STATE OF NORTH CAROLINA  
**DEPARTMENT OF TRANSPORTATION**

April 26, 2014  
Revised May 2, 2014

Subject: Proposed Glen Lennox Mixed Use Re-development  
Located on NC 54 at US 15-501  
Review of Traffic Impact Study

# Brandon Road Conventional Access

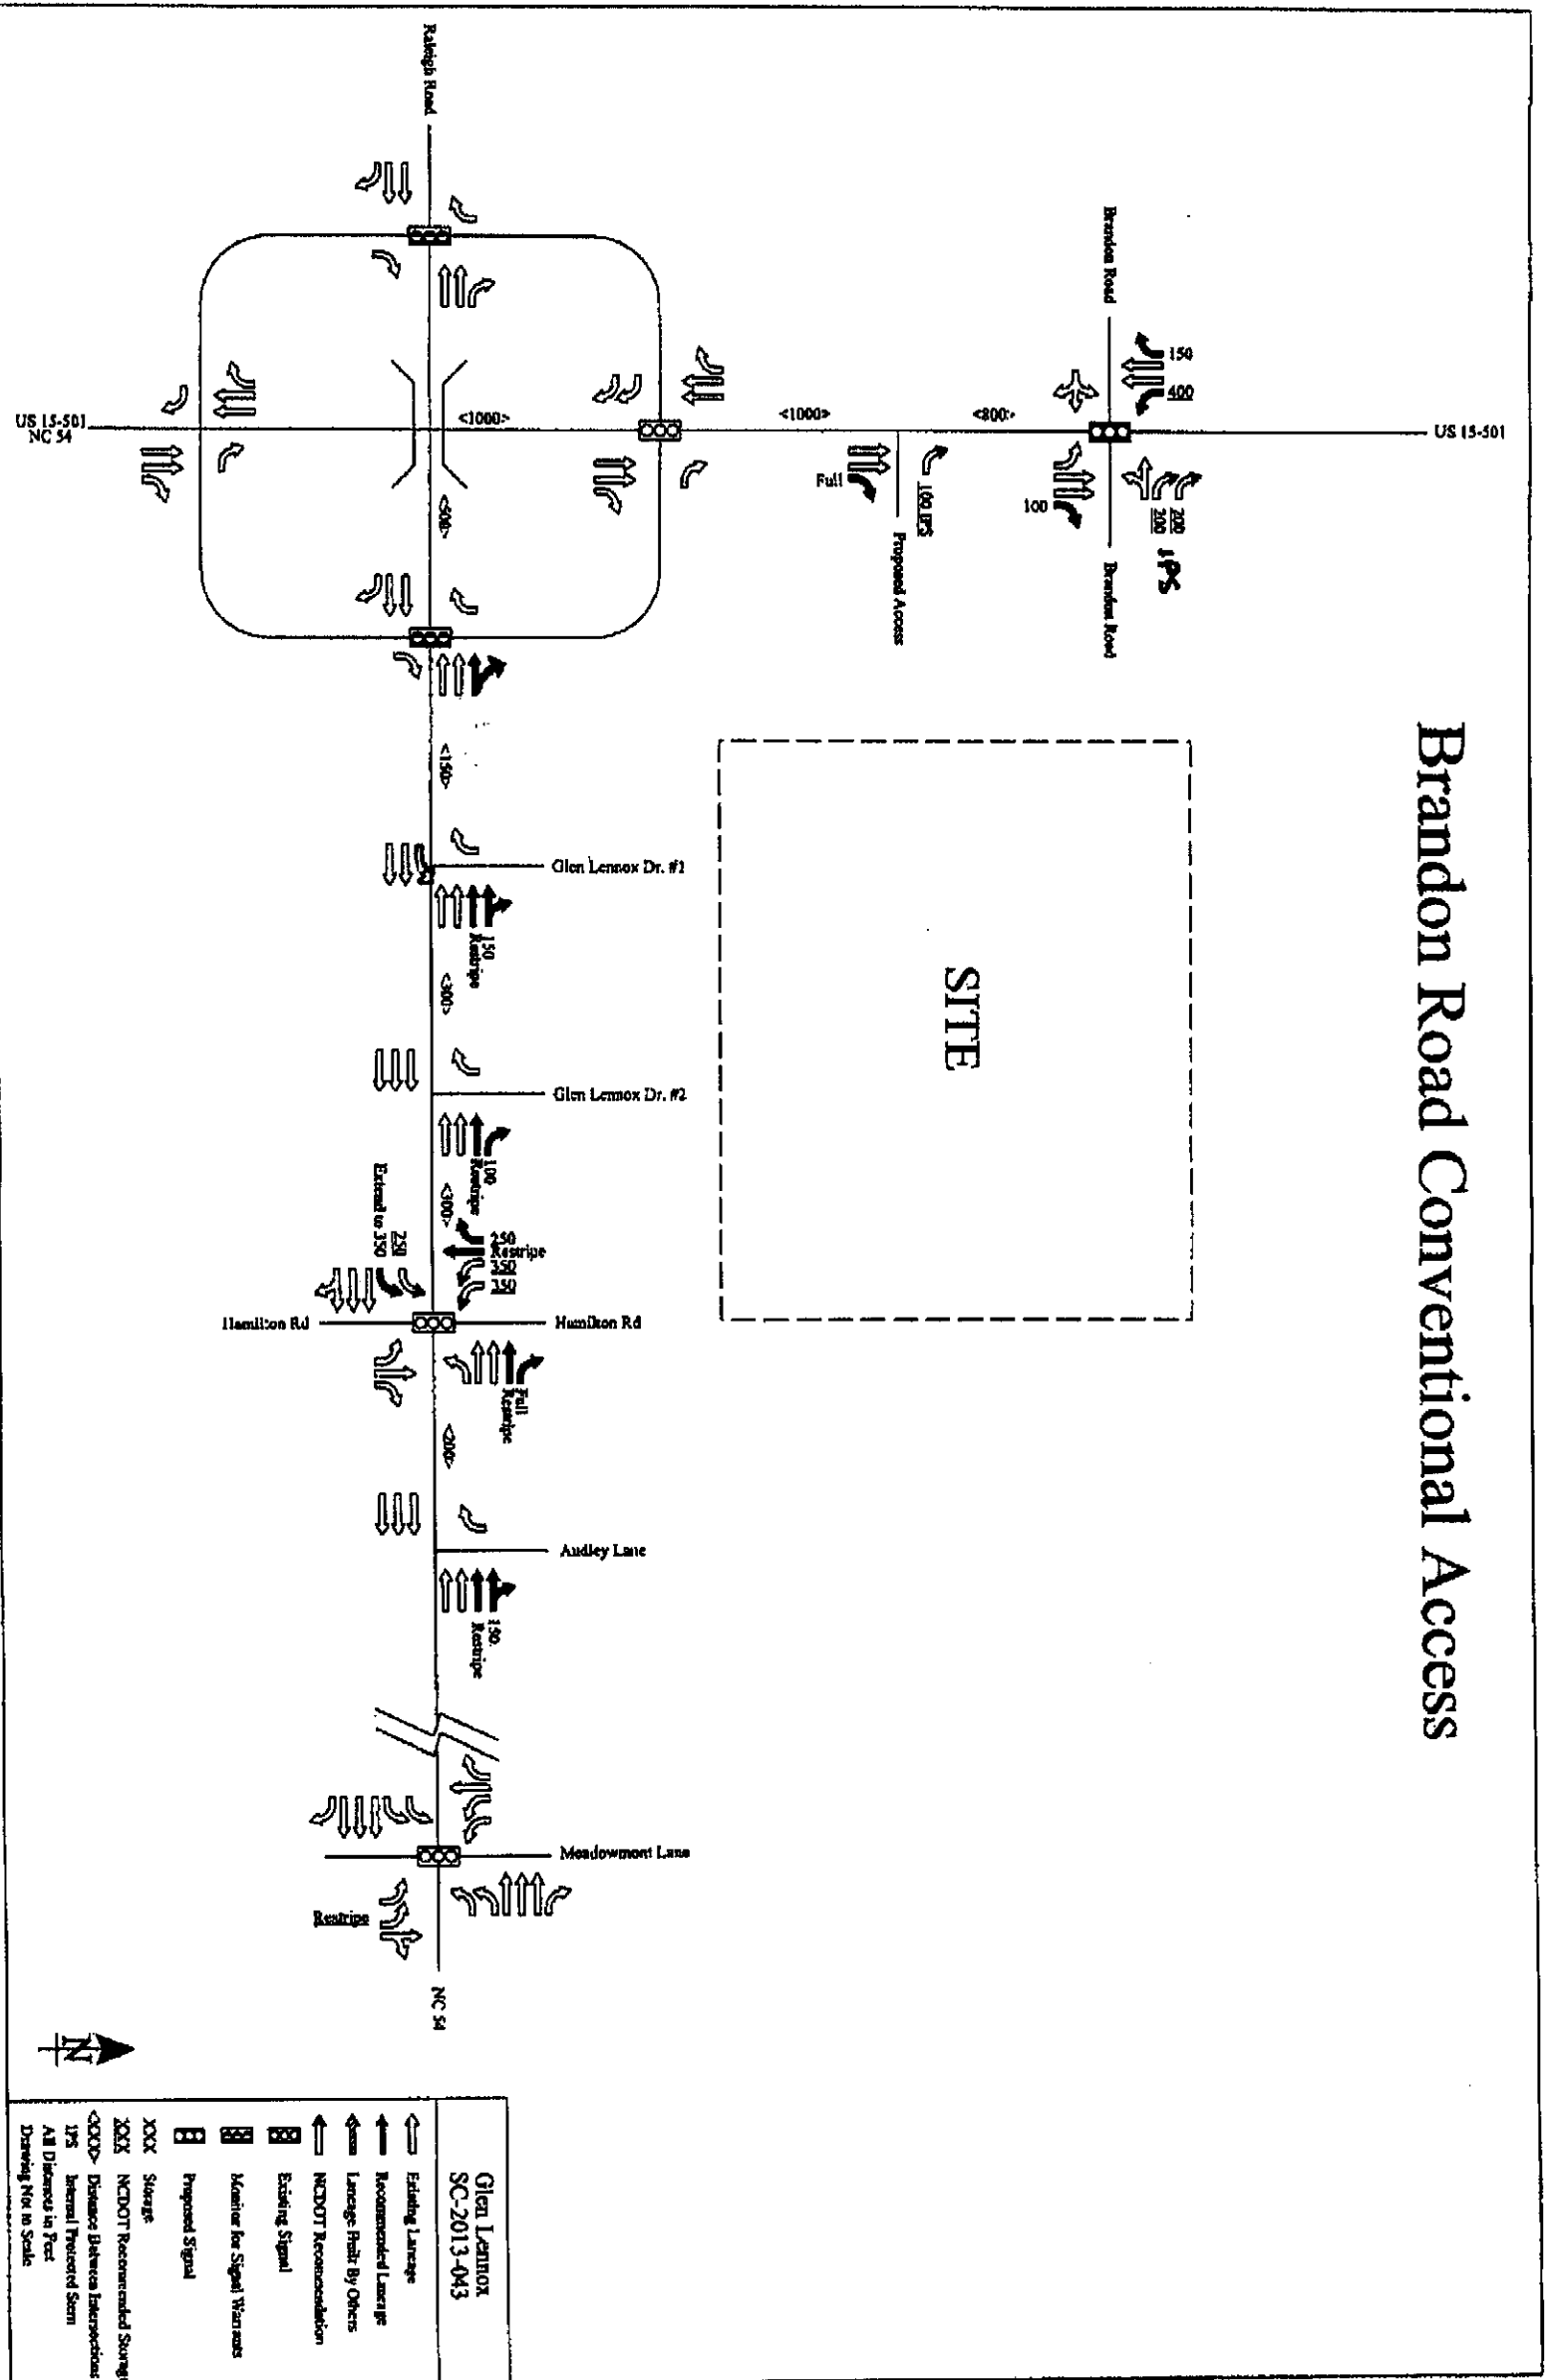
#### **Scenario 2- Brandon Road Conventional Access**

This configuration provides for an all-movement access at the existing Brandon Road/Christopher Road intersection controlled by a single multi-phase traffic signal. The proposed site access is restricted to right-in right-out only. In addition, as in scenario 1, the northbound acceleration lane from the NC 54 westbound ramp is extended to terminate as an exclusive right turn lane at the proposed access to provide for acceptable

acceleration and weaving distance to accommodate traffic maneuvers between the ramp and the intersection. Required lane configurations, storage lengths and additional geometric detail is provided on the attached graphic labelled “Brandon Road Conventional Access”
